WATER QUALITY MEMORANDUM

Utah Coal Regulatory Program

RE: 2009 Second Quarter Water Monitoring, Genwal Resources, Inc., Crandall Canyon Mine, Permit & Tracking #3335

Spring SP-58 Water Quality

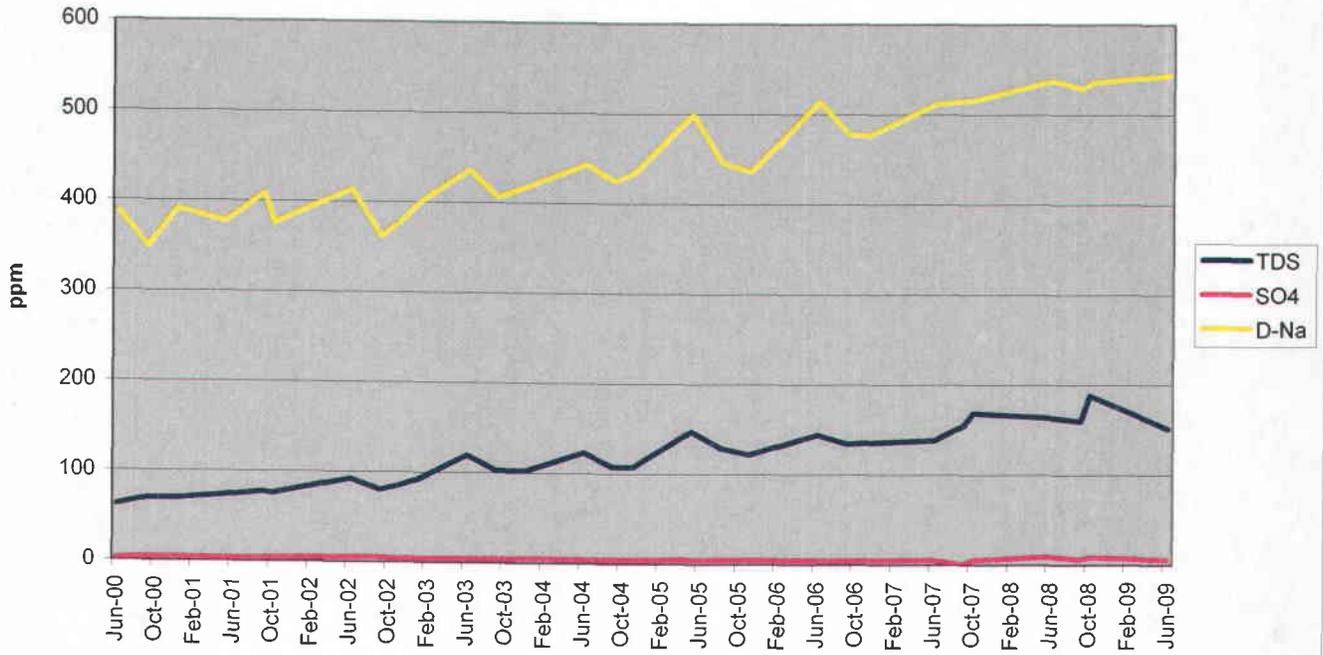
Spring SP-58 had produced several analytical results that were outside 2 standard deviations: D-Na (2.72 standard deviations), SO₄ (2.41 standard deviations) and TDS (2.01 standard deviations) during the 4th Quarter of 2008. However, the site was inaccessible due to snow conditions during the 1st quarter of 2009.

Analytical results obtained during the 2nd quarter of sampling for 2009 produced D-NA, SO₄ and TDS values that were again within 2 standard deviations as established by the data set. At this time, the exact cause for the elevated values during the 4th quarter of 2008 is unknown. Particular attention will be paid to this site and these parameters in future quarters.

Crandall Creek Lower Flume (LOF-1): Total Iron Levels

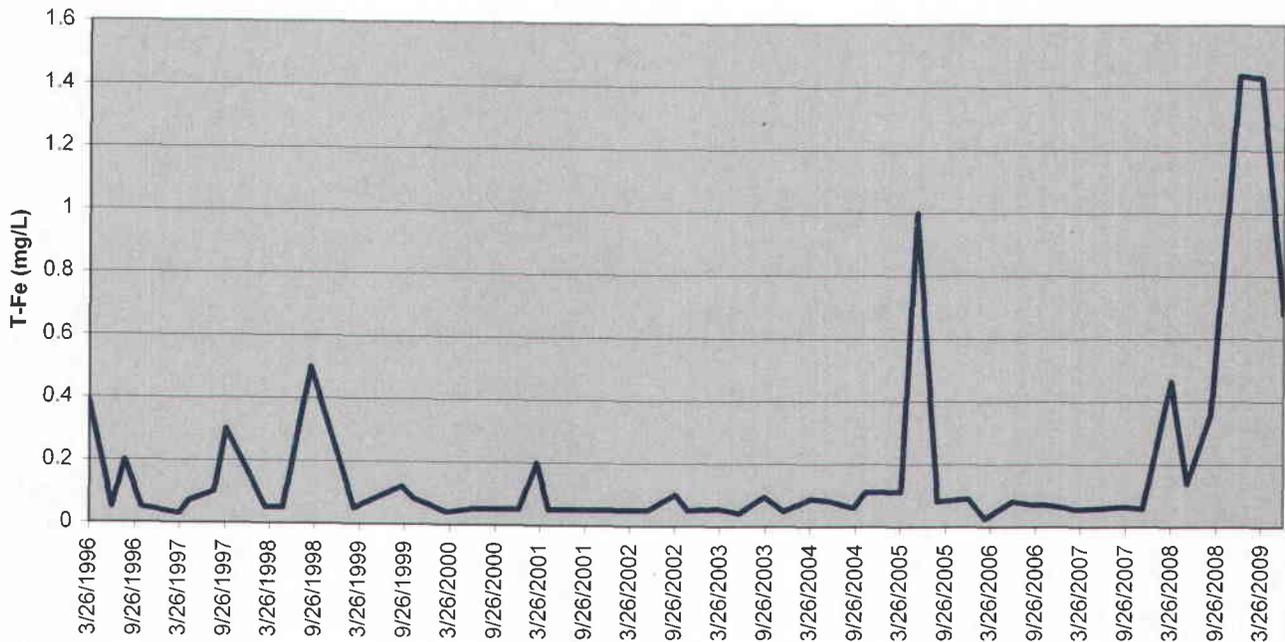
T-Fe levels measured below the mine facilities within Crandall Creek (Site LOF-1) dropped for the first time in two quarters. The previous two quarters had shown elevated levels of T-Fe (1.438 ppm 4th Qtr. 2008 and 1.432 pm 1st Qtr. 2009). However, the T-Fe levels obtained from Site LOF-1 within Crandall Creek for the 2nd quarter of 2009 was 0.679 ppm.

Total Iron (T-Fe): Outfall 002

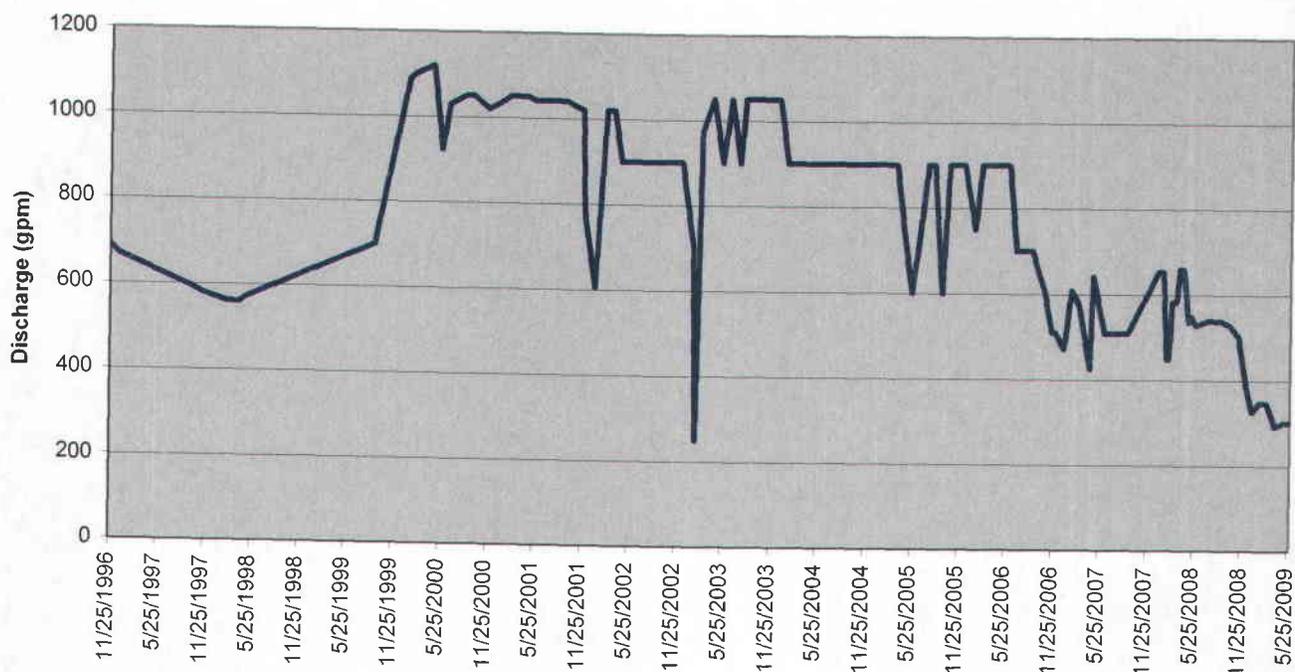
The results from the 4th quarter of 2008 again produced levels of TDS below the UPDES standard of 1,200 ppm. However, T-Fe values had increased to levels beyond the 1.0 ppm range established in the UPDES permit (1.59 and 1.335 ppm respectively for 4th qtr., 2008).

Mine-water analytical results for the 1st quarter of 2009 were again a mixed bag of compliant TDS levels with elevated T-Fe levels (1.783 ppm, 2.454 ppm and 2.23 ppm for T-Fe).

The sampling results for the 2nd quarter of 2009 followed the same pattern as produced during the previous quarter: compliant TDS levels combined with three samples producing T-Fe levels well over the 1.0 ppm criteria established in the UPDES permit. Sampling events on April 6th, May 6th and June 3rd produced T-Fe levels of 2.455 ppm, 2.331 ppm and 2.501 ppm respectively.

Continued data collection and monitoring of the mine-water discharge will be necessary to evaluate the T-Fe levels.

Continue to work with the Permittee in identifying a mine-water treatment system that will effectively lower the T-Fe concentrations to compliant UPDES levels.

Total Dissolved Solids (TDS): Outfall 002

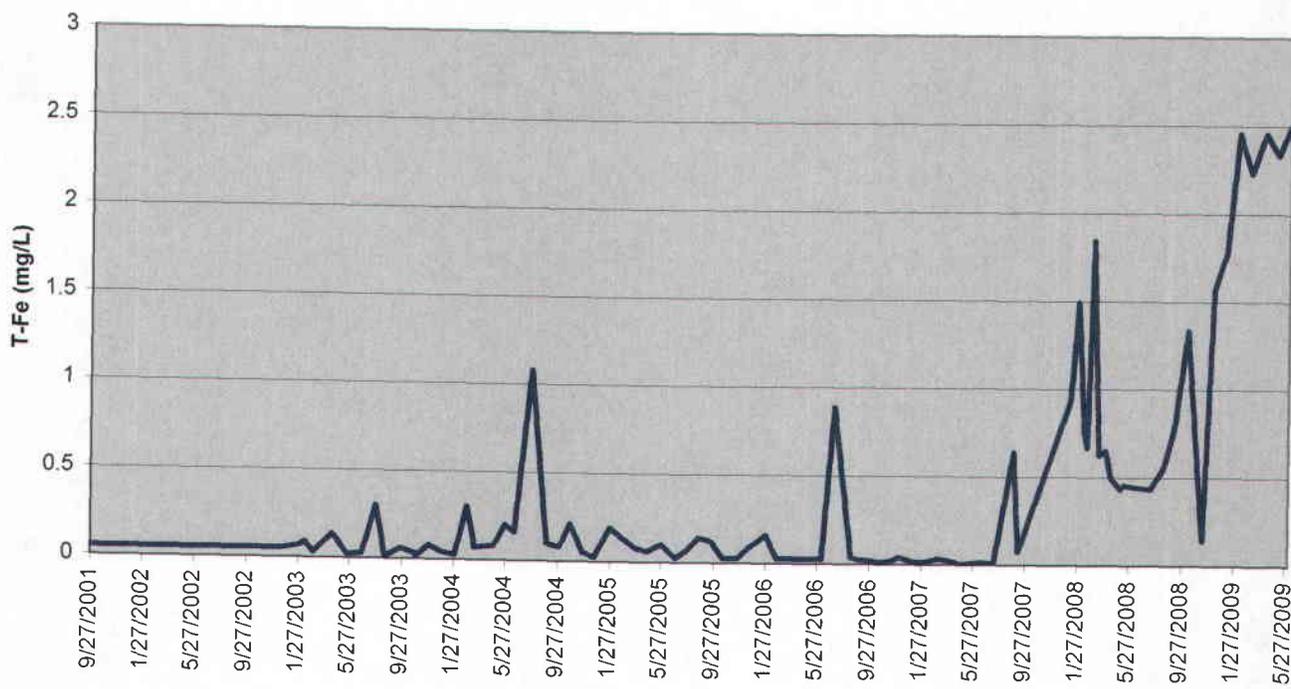
Three months following the sealing of the north portals, the mine water discharge began to exhibit fluctuating levels of T-Fe and TDS at UPDES Outfall 002. The 1st quarter of 2008 produced analytical results that were outside the Permittee's UPDES compliances levels for both TDS and T-Fe.

However, during the 2nd and 3rd quarters of 2008, analytical results obtained for TDS and T-Fe from the mine-water discharge were within the compliance levels established by the UPDES discharge permit (1.0 ppm for T-Fe and 1,200 ppm for TDS).
